Subject: Addendum No. 2 to Request for Proposals – Access Control Platform Migration or Replacement Project

Please be advised that the City of Cleveland, through its Director of the Department of Port Control (“Department”), hereby publishes Addendum No. 2 to the Request for Proposals – Access Control Platform Migration or Replacement Project, dated October 19, 2018.

PANIC BUTTON BAGGAGE LEVEL MAP			
Designed:	Drawn:	Checked:	Approved:
-	LUSTRI	SLATER	-
Scale:	1" = 50'	WBS No.:	-
Date:	NOV 5, 2018	Sheet:	1

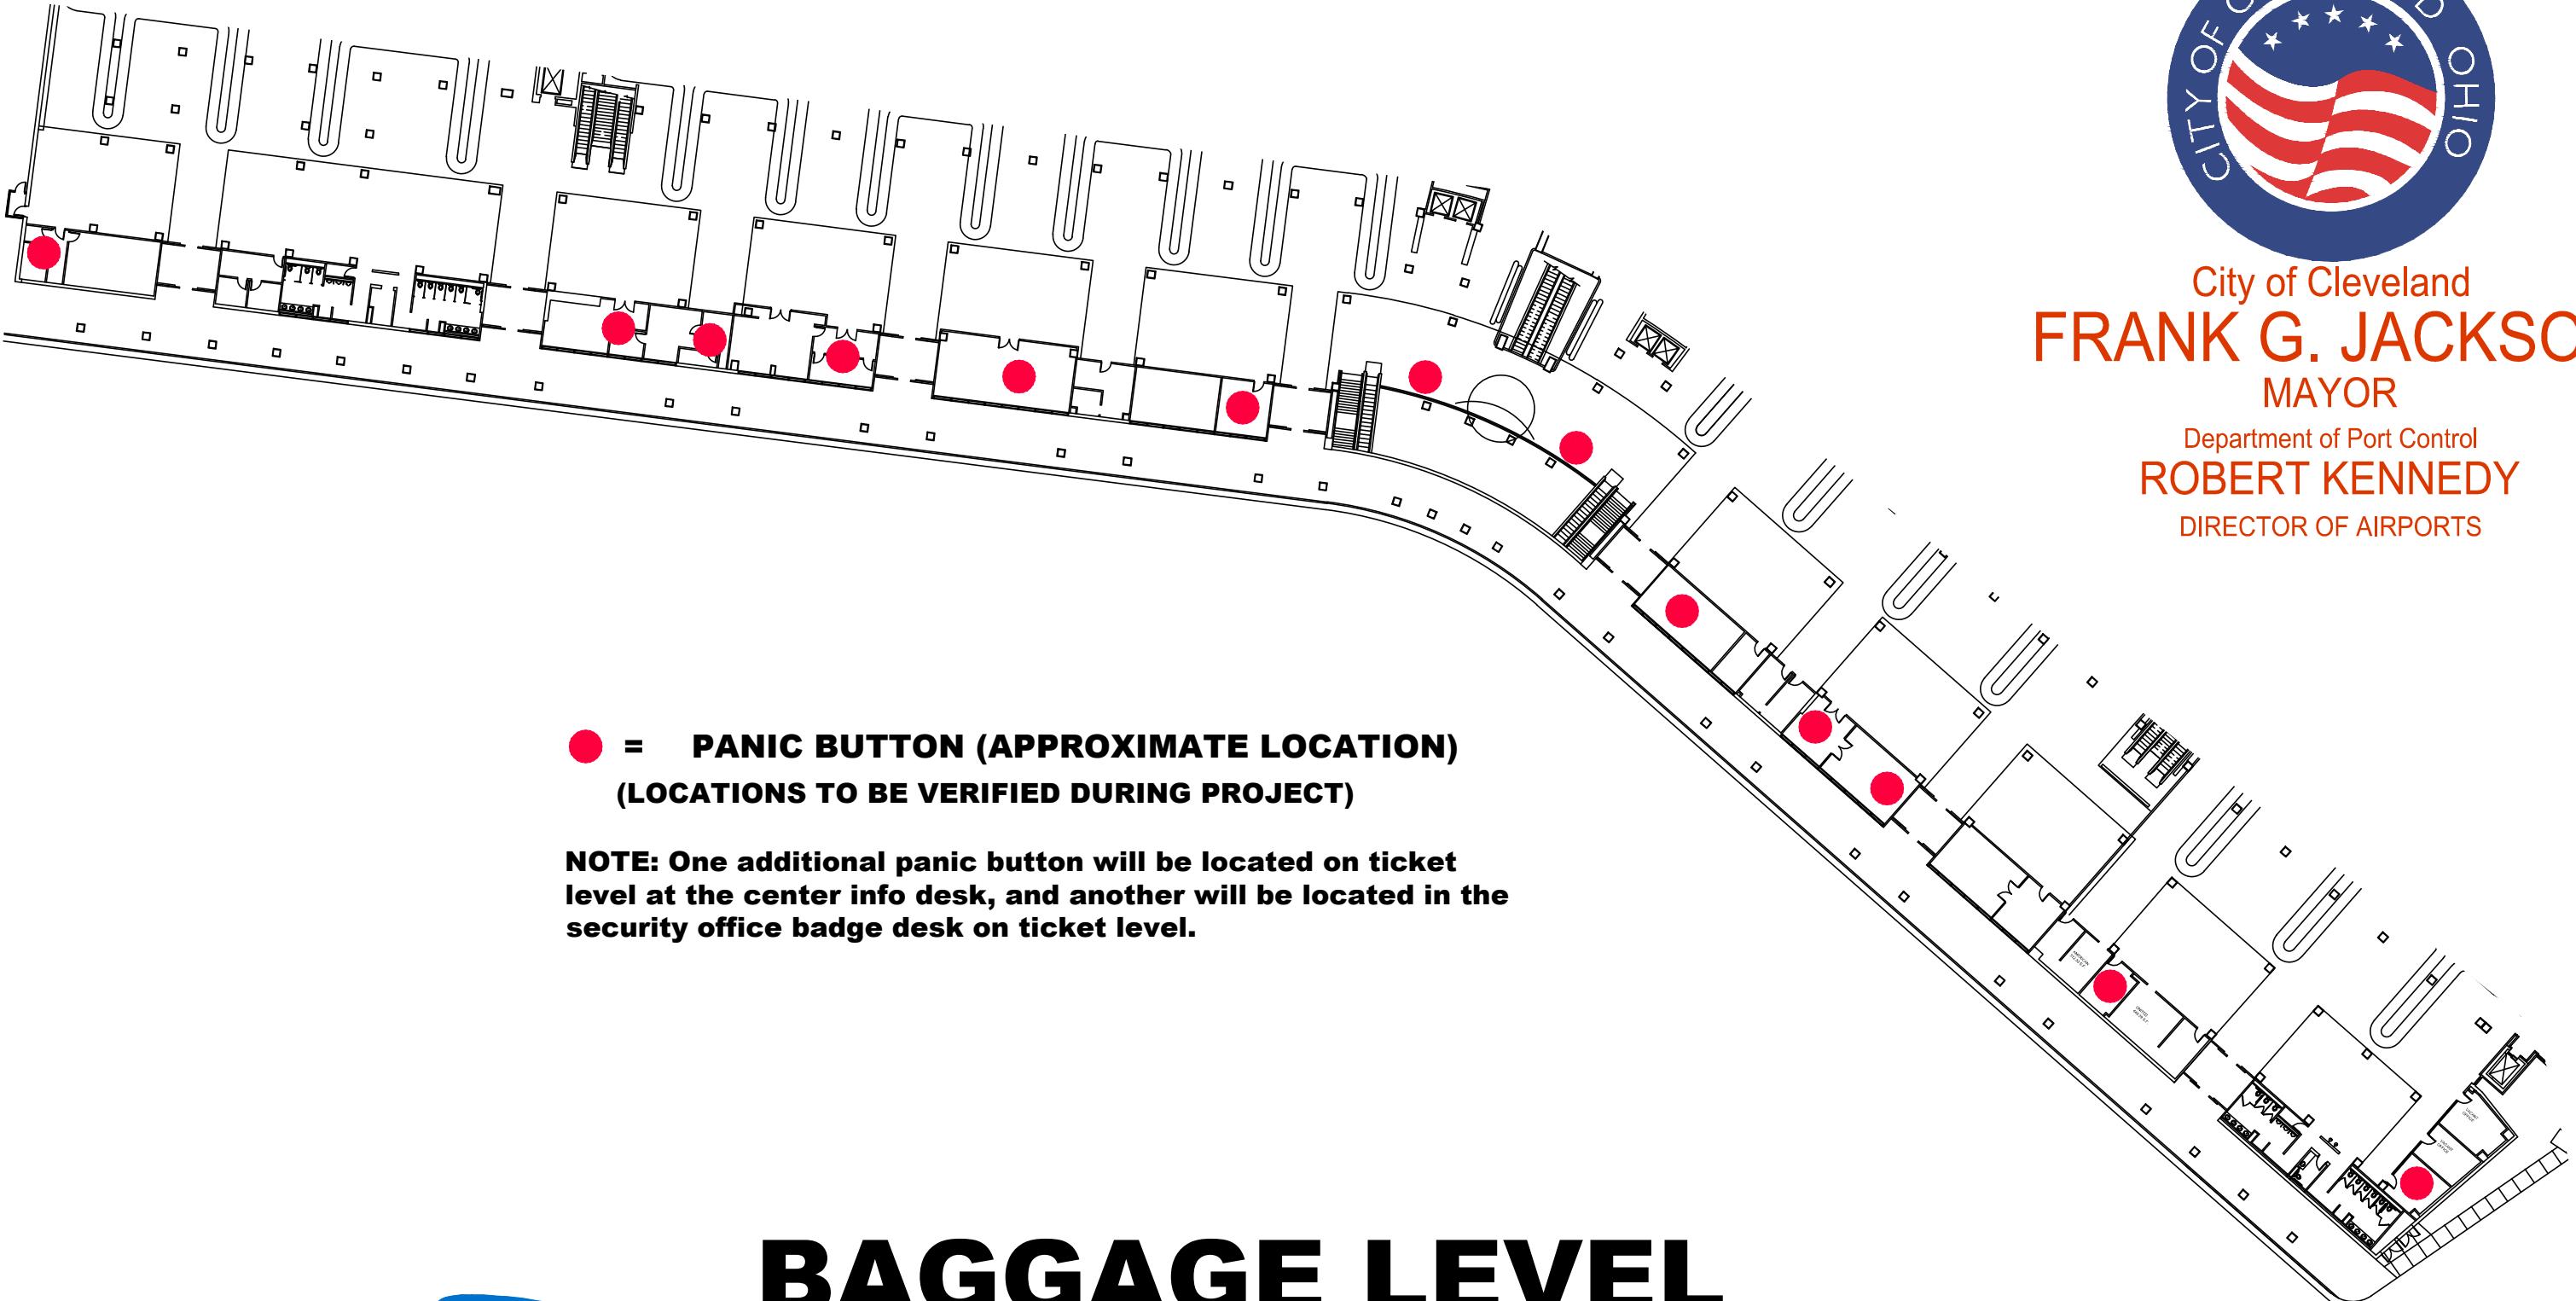
11.	Question	Section: Access Control Core System, page 7, item 30 – Does the Department have a drawing with the locations of where you want the panic buttons installed? The Department is asking for a firm price, from the proposing firm, and in order to do so, we would need these locations.

Answer	A map is part of this Addendum 2. The panic buttons shall function in a manner that sends an alarm to operations within the access control monitoring system. If a wireless solution is submitted, keep in mind the amount of concrete in the area that effects wireless signals. Also

the amount of signals already in the vicinity may cause unstable conditions. The department is looking for the most economical solution to achieving this result.
